Public Works Department – Engineering Division

ADDENDUM NO. 2

PROJECT 2019 BART PEDESTRIAN AND BIKE CONNECTIVITY

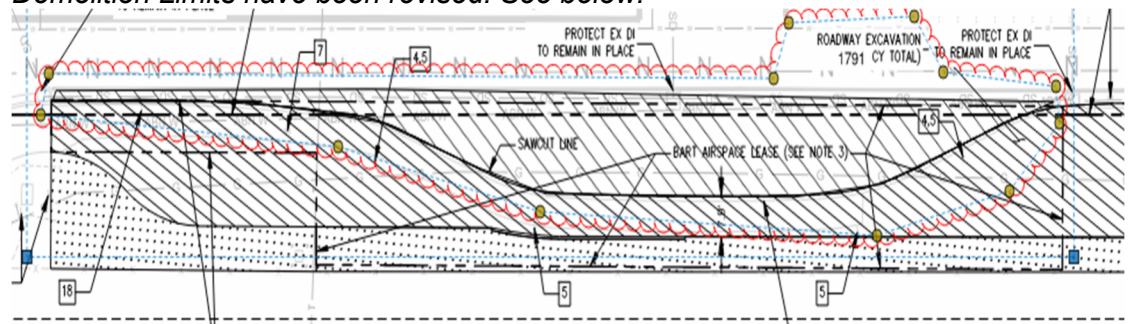
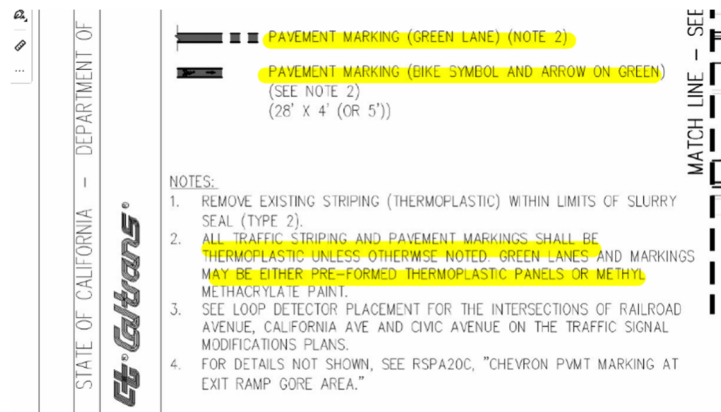
32. Asphalt demolition limits do not match new asphalt roadway limits.

Demolition Limits have been revised. See below.

Bid Item #16 Roadway Excavation quantity has been revised to 1791 CY. See Revised Bid Schedule, Attachment A.

CITY OF PITTSBURGH	NO.	DATE	REVISION	DRAWN BY:	CM	STANDARD DETAIL HIGH GAIN ANTENNA	SHEET 1 OF 1 I-5
				CHECKED BY:	MK		
				DATE:	2019-01-11		
				SCALE:	NTS

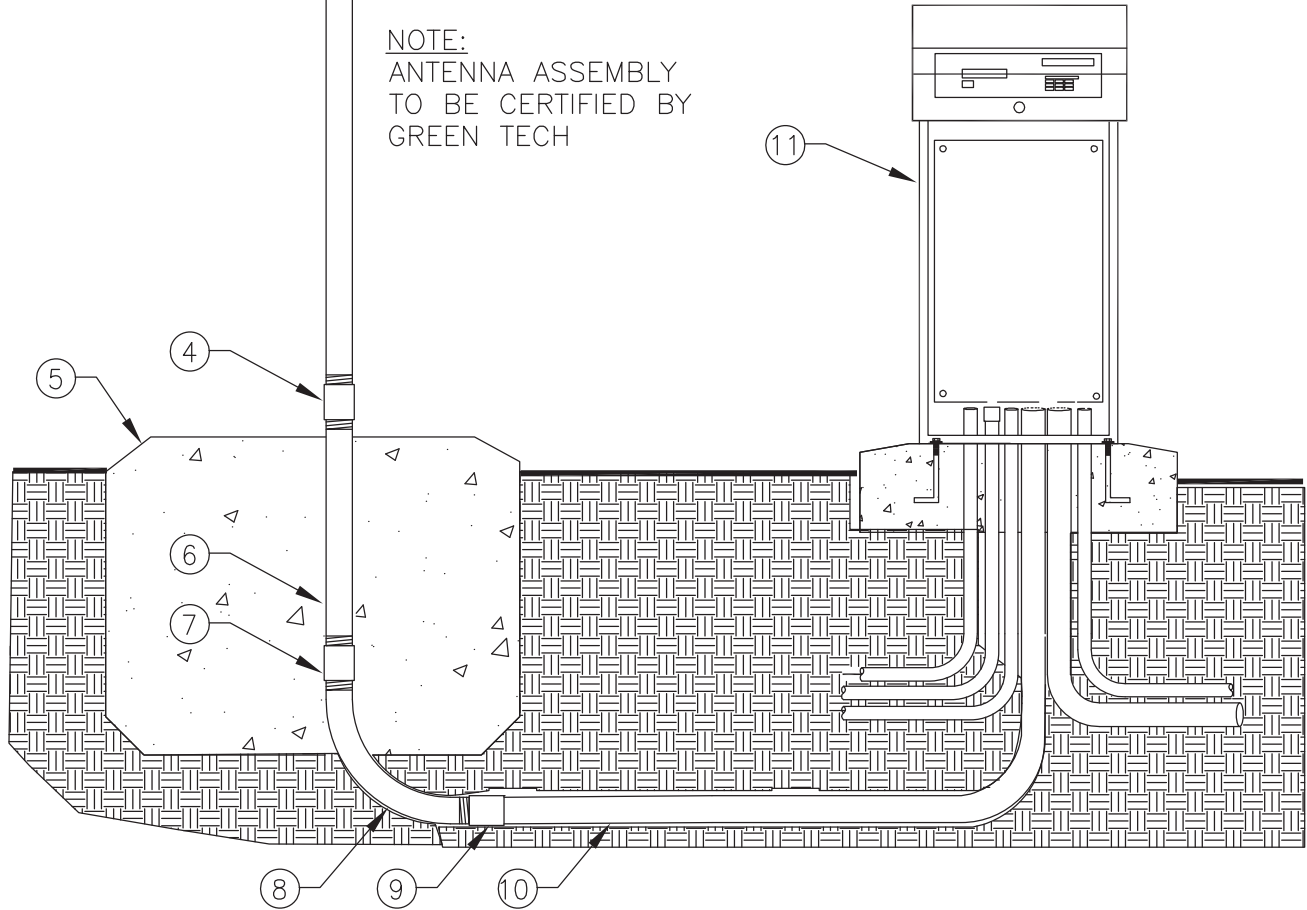
10. Detail I-4/ sheet 3 of 3 on sheet I-8 shows antenna. Please provide a location, model number and detail of antenna for bidding purposes.

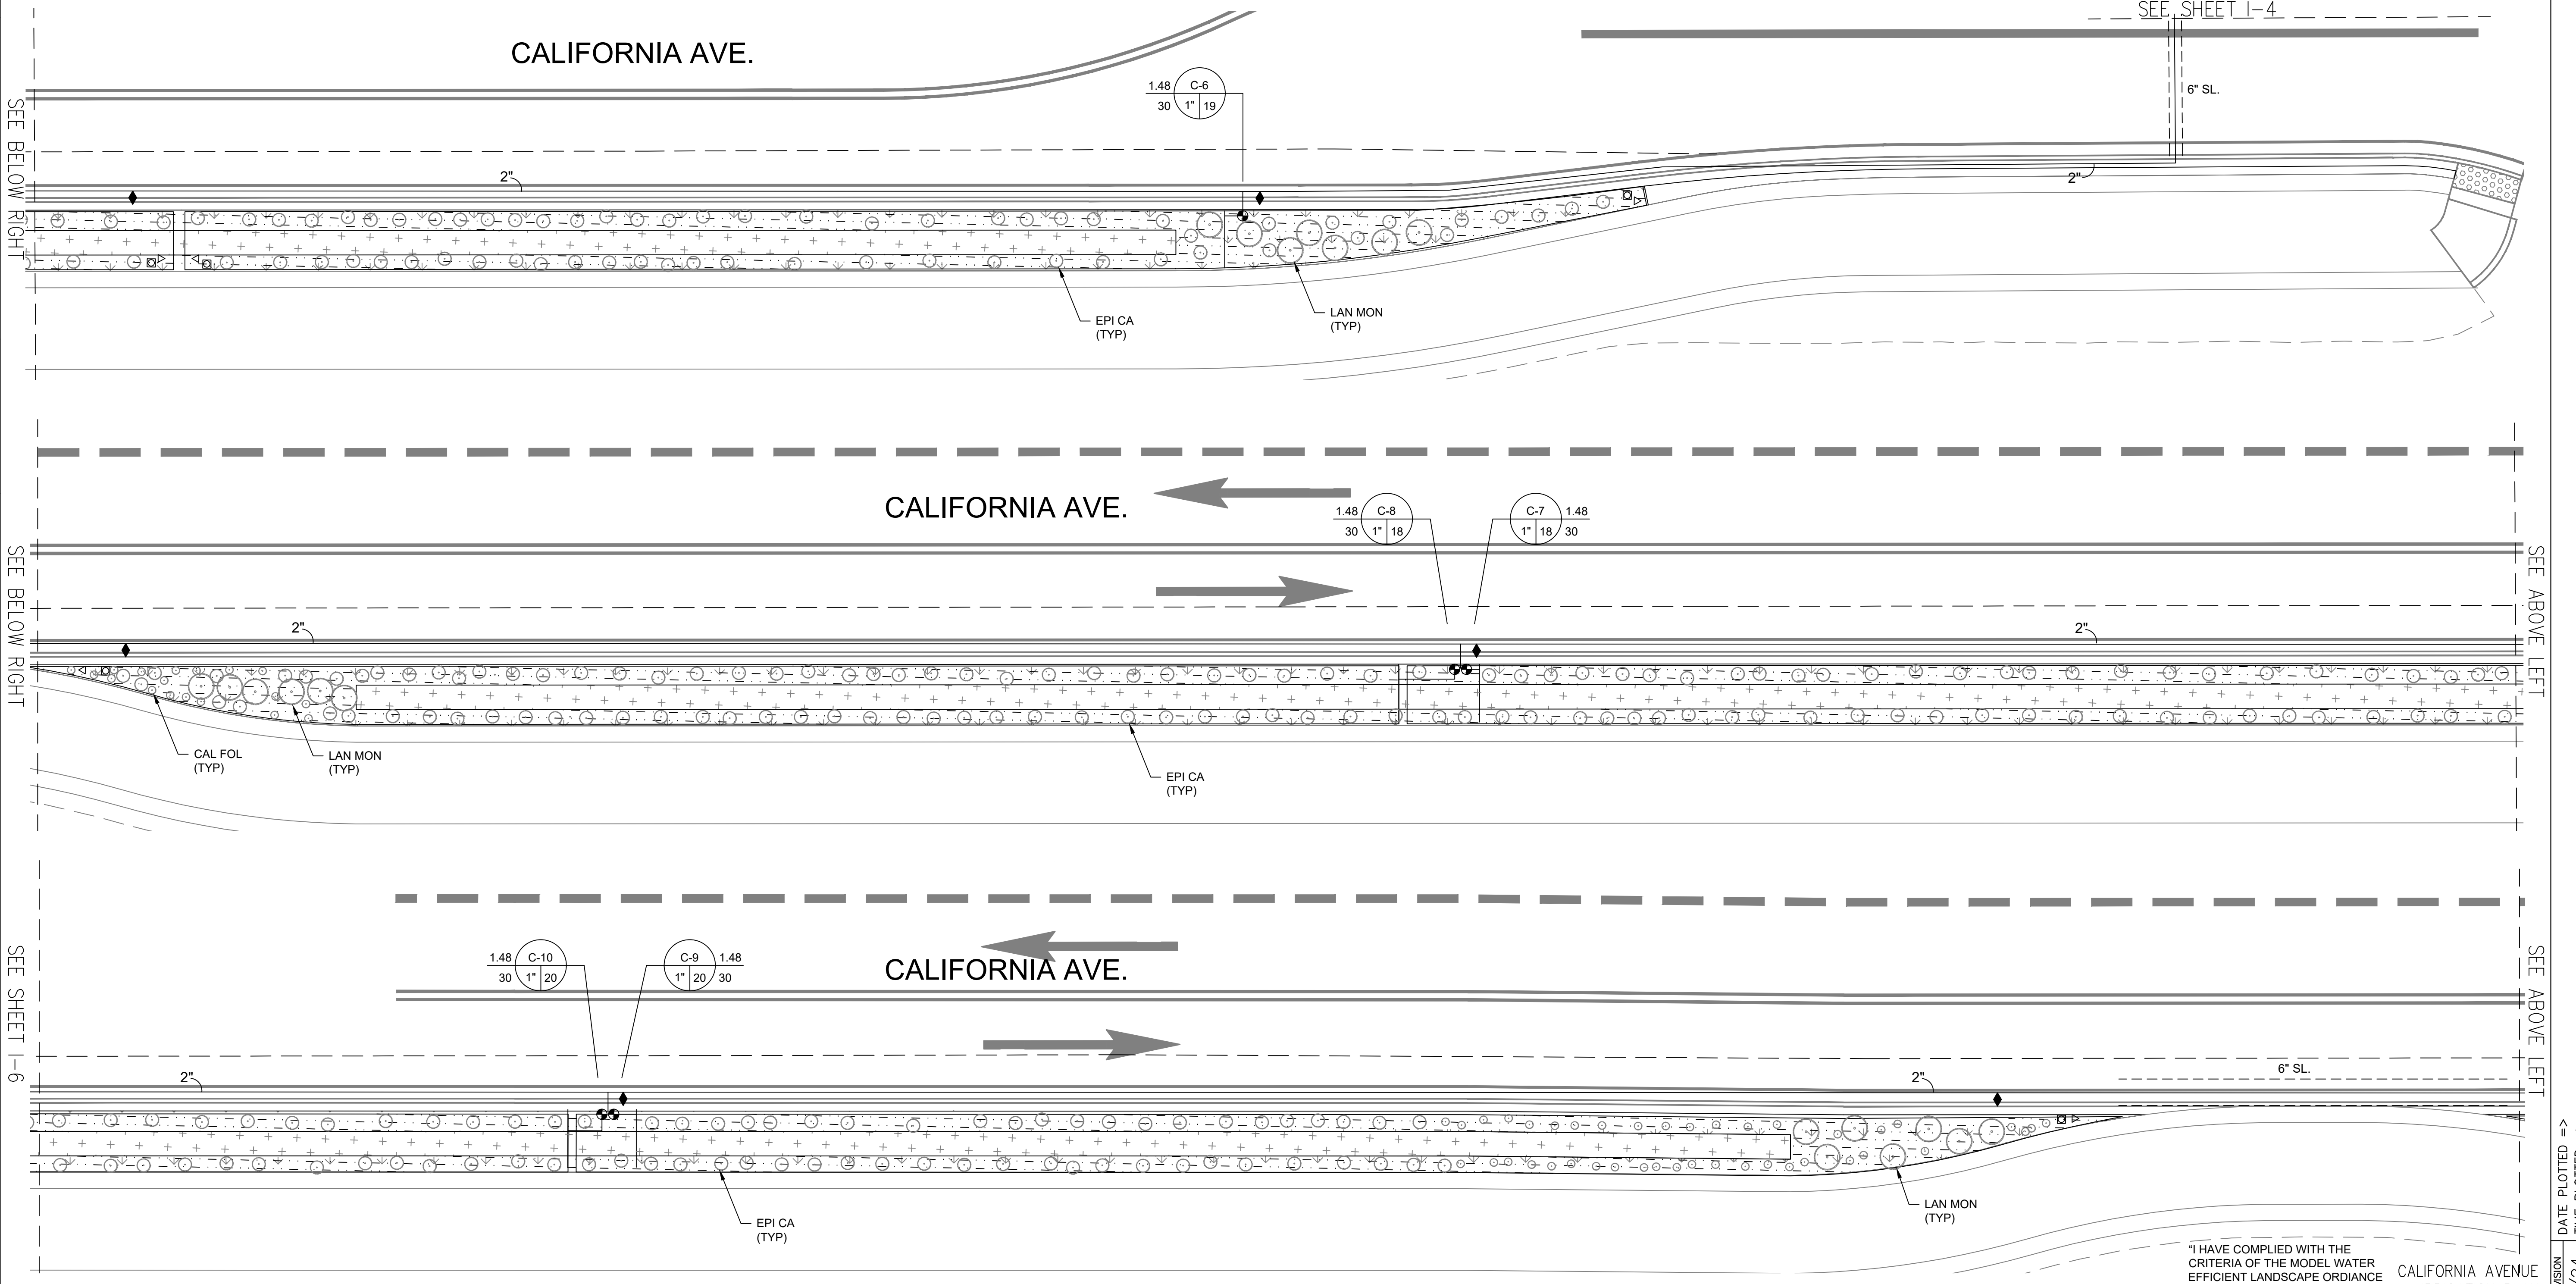
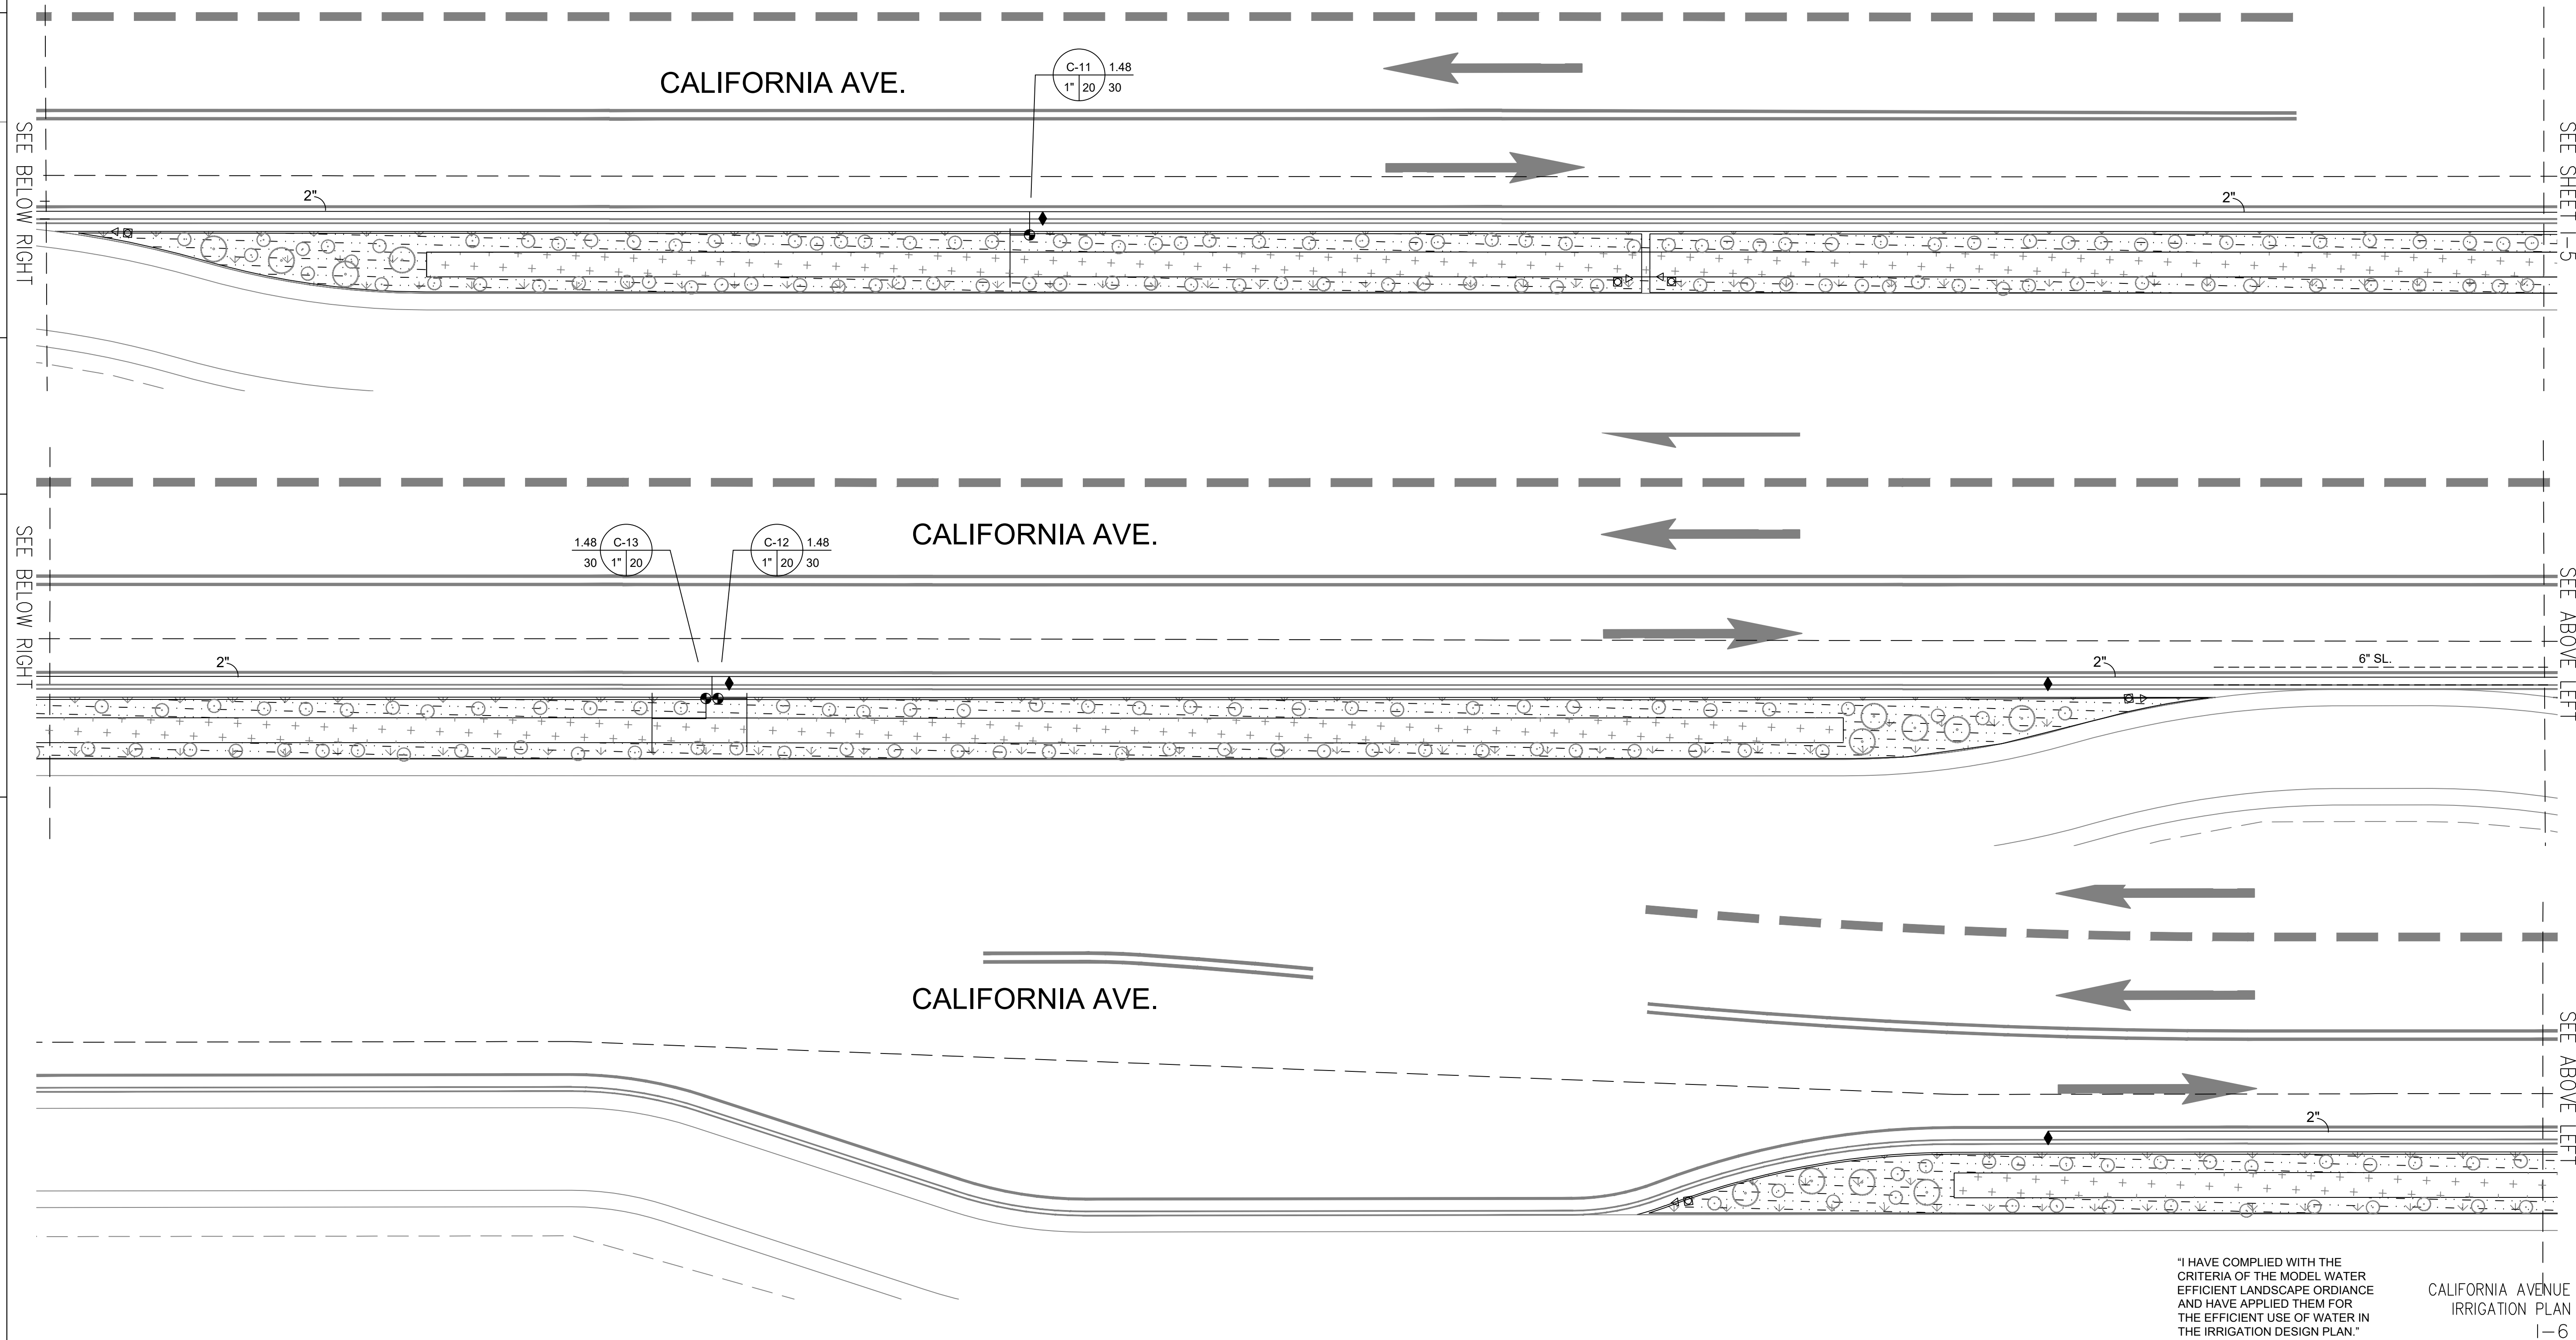
- Referring to sheets L-1 through L-4, I-5 and I-6, it looks there are proposed planting areas along the new trail at California Avenue that are missing. Please clarify.

-
24. According to sheets I-5 and I-6, there are eight remote control valves along California Avenue that are located on the mainline from basin with controller D (sheet I-4) but labeled "C". Please clarify if these valves should be named "D" and wires routed to controller D at the basin.

See revised Sheets I-5 and I-6 for planting and L-1 through L-4 for notes, legend, or abbreviation.

Correct. The valves shall be D.
